Re: Petition No. 1341: A Petition Of The Durham Manufacturing Company To Approve By Declaratory Ruling The Construction And Operation Of A Solar Photovoltaic Electric Generating Facility At 201 Main Street, Durham, Connecticut

**RESPONSES OF DURHAM MANUFACTURING COMPANY TO
CONNECTICUT SITING COUNCIL INTERROGATORIES**

E-6.1

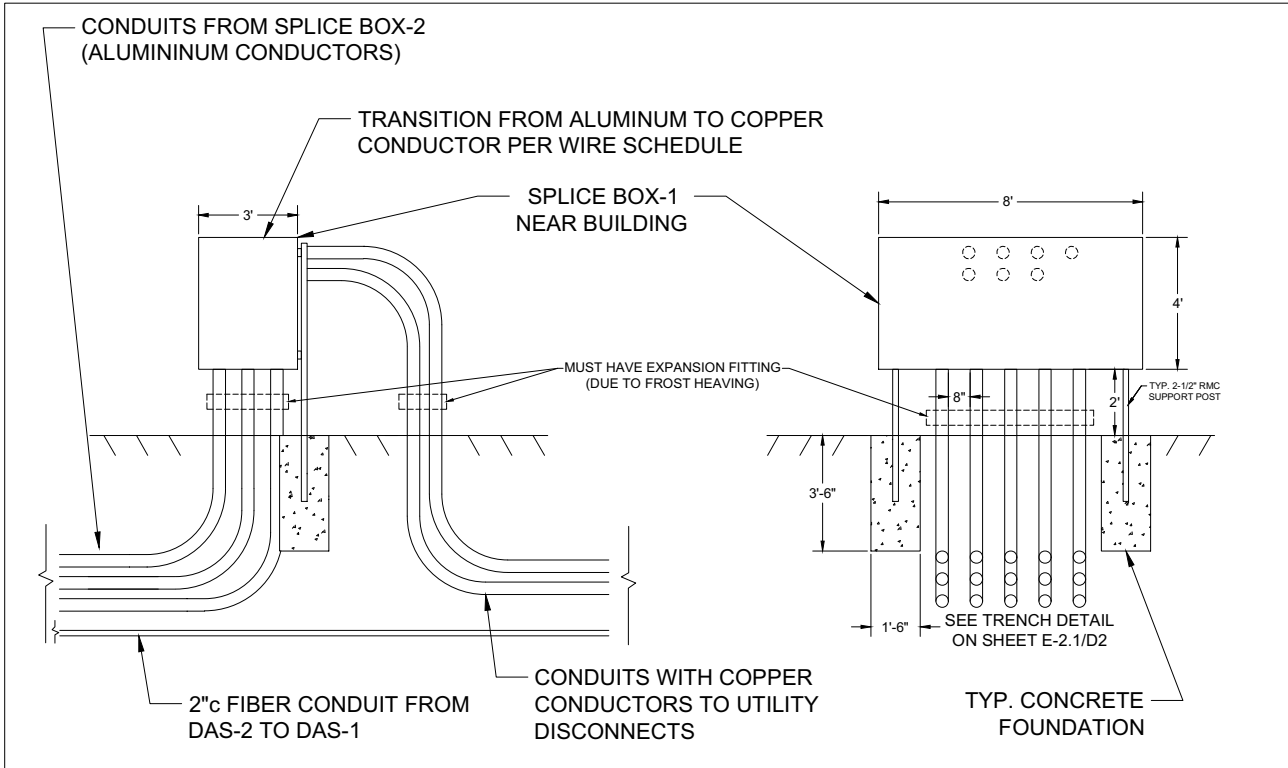
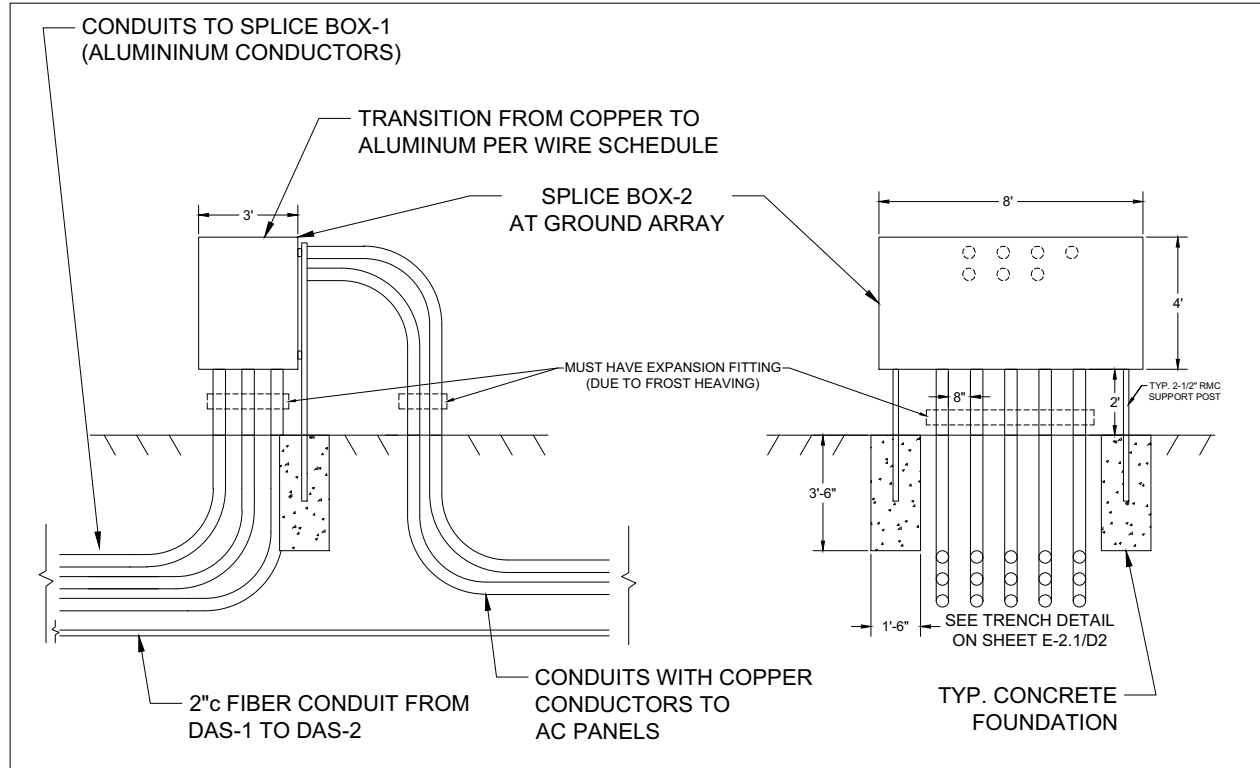
Referring to Petition Site Plan SP-2, provide specifications/design for the electrical equipment.

Site Plan SP-2 has been revised to show a more detailed layout of the electrical equipment. See revised site plans provided at Attachment C. Technical specifications for electrical equipment are provided in Attachment B (Sheets E-2.1, E-6.1 and E-6.2). Sheets E-

3 **CHAIN-LINK FENCING & GATE DETAIL**
DN-1 SCALE : N.T.S.

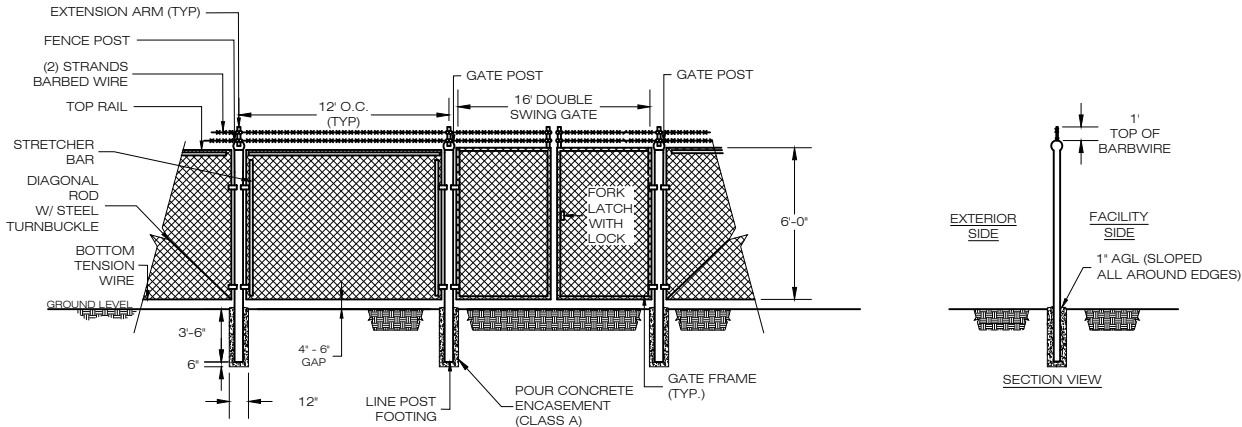
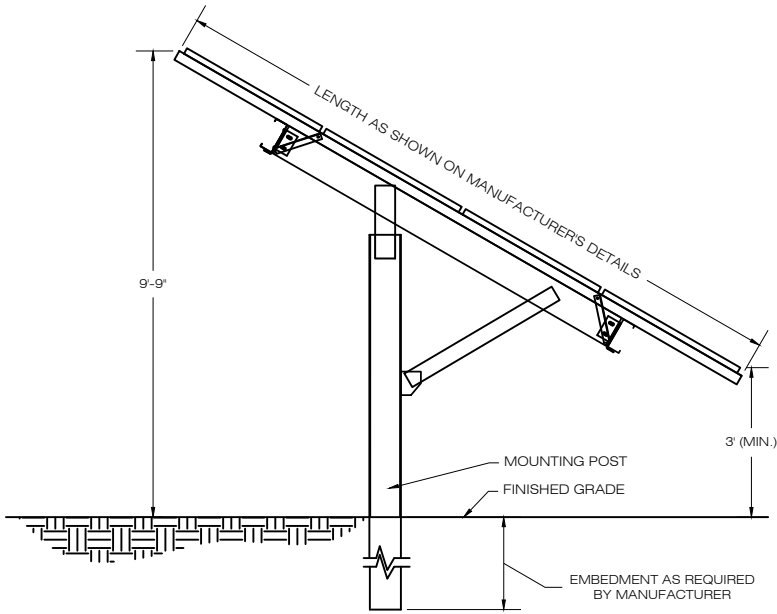
Referring to Site Plan DN-1, what is the distance between the bottom fence edge and ground level? Could the fence be designed so that bottom edge of the fence allows for small animal movement?

The revised Site Plans, provided in Attachment C, have been modified to reflect a four to six inch gap between the ground surface and the bottom of the fence to allow for small animal movement. See Sheet DN-1.
